## Access Compliance Report Public Rights-of-Way (Curb Ramps)

Intersection ID: 48985 Main Street: AVONCLIFF\_DR Cross Street: KINGSDOWN\_AV Location: SW

ADA ID: 21374AFDA802 Ramp Type: PerpDiag Initial Pass/Fail: Fail Overall Compliance: No Severity Score: 33.75

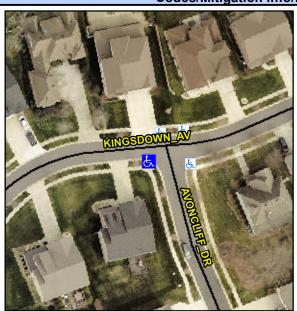
R304.5.1, R304.5.3

Field Measurements/Component Compliance						
Compliance Description		Data	Comp	oliance Description	Data	
1	N/A	Ramp Length (in)	69.0	Yes	Ramp Slope (%)	7.2
1	No	Ramp Width (in)	47.5	No	Ramp XSlope (%)	7.4
N	N/A	Flare Type LT	N/A	N/A	Flare Type RT	N/A
1	N/A	Flare Slope LT (%)	N/A	N/A	Flare Slope RT (%)	N/A
1	N/A	Flare Traversable LT?	N/A	N/A	Flare Traversable RT?	N/A
1	N/A	Landing Length (in)	N/A	N/A	DWS Provided?	N/A
1	N/A	Landing Width (in)	N/A	N/A	DWS Contrast?	N/A
1	N/A	Landing Slope (%)	N/A	N/A	DWS Length (in)	N/A
1	N/A	Landing X Slope (%)	N/A	N/A	DWS Full Width?	N/A
1	N/A	Landing Curb? (Y/N)	N/A	N/A	DWS Offset (in)	N/A
1	N/A	Shared Landing?	N/A			
1	N/A	Gutter Ponding?	N/A	N/A	Gutter Slope (%)	N/A
N	N/A	Gutter Lip Ht (in)	N/A	N/A	Gutter X Slope (%)	N/A
1	N/A	Painted X Walk1?	No	N/A	Painted X Walk2?	No
		X Walk 1 Direction	То Е		X Walk 2 Direction	To N
1	N/A	X Walk 1 Width (in)	N/A	N/A	X Walk 2 Width (in)	N/A

Remove & Replace Curb Ramp With
Two New Directional Ramps or
Equivalent.
